**Chemung County Stormwater
Construction Inspection
Erosion and Sediment Control**

Project Name Hickory Grove Solar Project	Date 4-27-21
Location Hickory Grove Road Horseheads, NY	Permit # NYR11F809
Weather Conditions sunny	Entry Time: 1:43 pm
On-Site Representative Present: Zack Gillespie, APA	Exit Time:

PROJECT: Hickory Grove Road Solar
Town of Horseheads
Municipal Construction Inspection
April 27, 2021

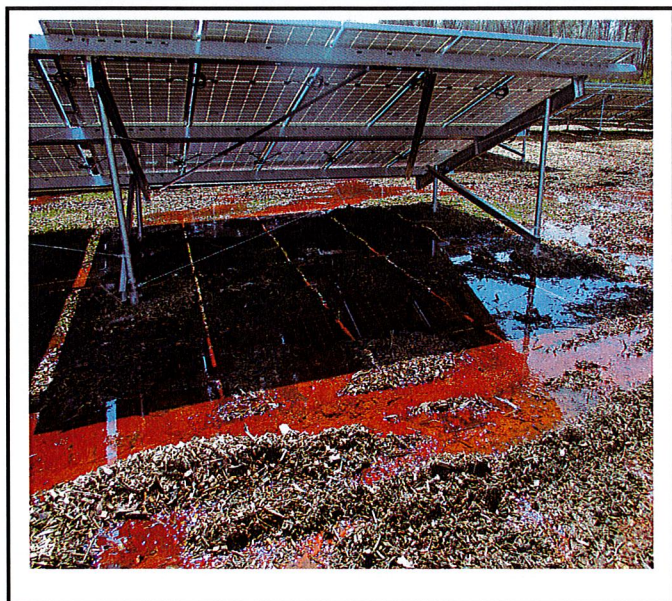
Severe compaction with no stabilization.

Open idle areas were left unstabilized all winter.

Standing water issue.

Severe compaction and standing water issue.
